Joseph M. Farley Nuclear Plant – Unit 1
Response to NRC Request for Additional Information –
Proposed Relief Request FNP-ISI-RR-01

**Response to NRC RAI Regarding Proposed Relief Request FNP-ISI-RR-01
for Farley Nuclear Plant, Unit 1**

FARLEY 1
 OUTLET SAFE END DETECTION SCANS
 25° ALA1-4100-1DM
 145° ALA1-4300-1DM
 265° ALA1-4200-1DM
 FIGURE 1

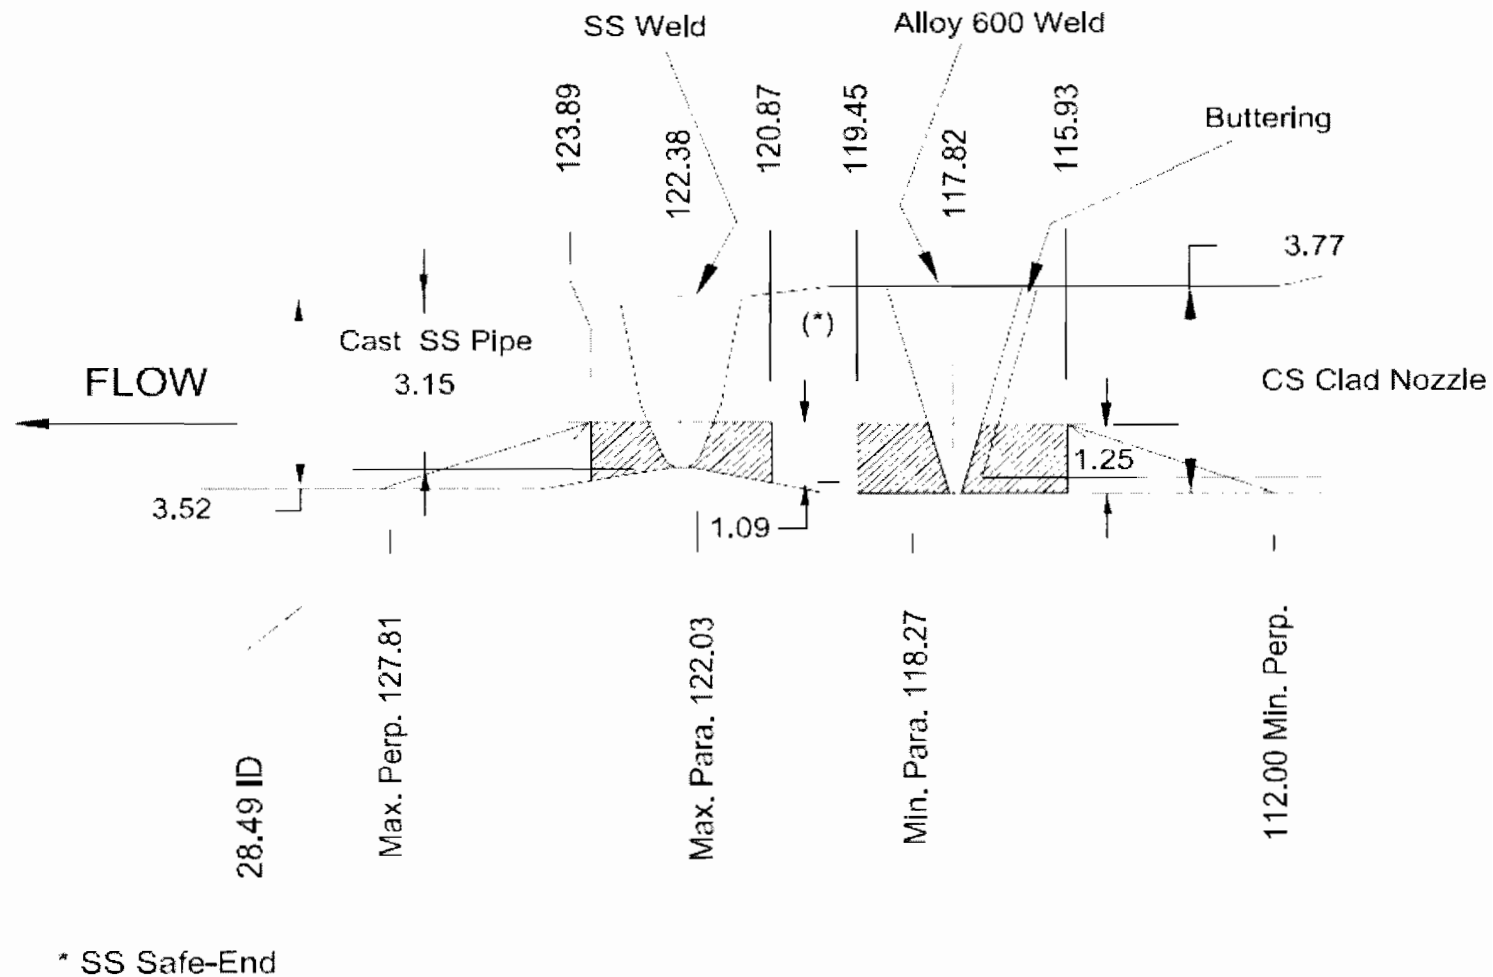
Some details about the welds were not included in the relief request. Provide detailed cross-sectional diagrams including sketches of the weld area. These diagrams should identify the materials (stainless steel, carbon steel, nickel alloy) of the base metal, weld, and buttering and show dimensions (Nominal inside diameter (ID), outside diameter (OD), and wall thickness) for each of the welds.

Figures 1 and 2 show the hot-leg and cold-leg drawings, respectively. The drawings show both configuration and materials.

FARLEY 1
25° Hot Leg Loop 1
FIGURE 3

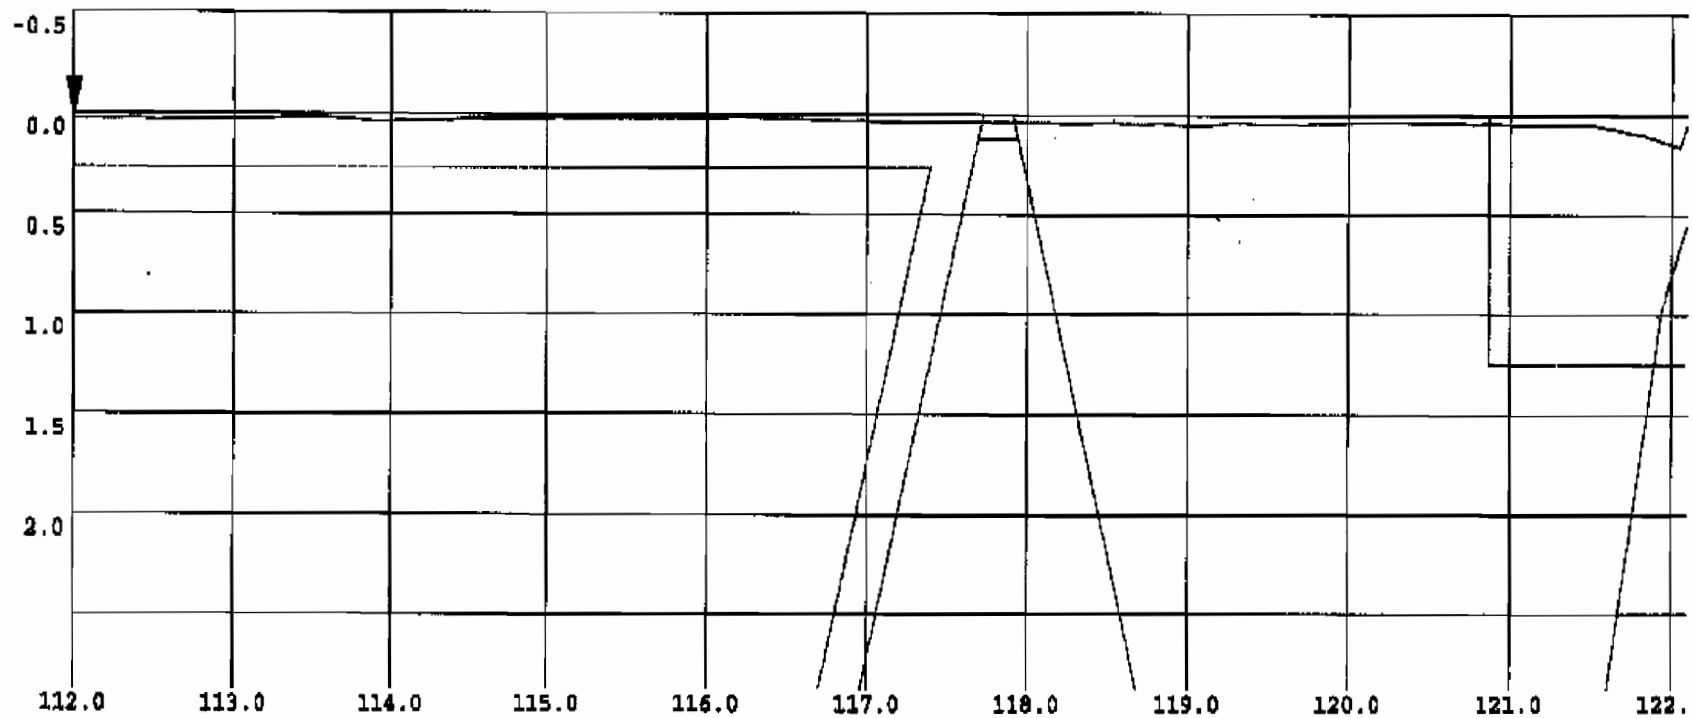
Has profilometry been previously performed on any of these welds? If yes, provide a description of the surface waviness and estimate the percentage of areas with suspected probe lift-off.

Profilometry using UT methods was performed on the ID surface during the fall 2007 1R21 outage at Unit-1. The surface condition of the nozzle to safe-end welds were relatively smooth with no lack of coverage noted. A more recent examination on Farley-2 was completed during the fall 2008 2R19 outage with similar results. Figures 3, 4, and 5 provide representative profilometry profiles for Farley-1 hot-leg nozzles.
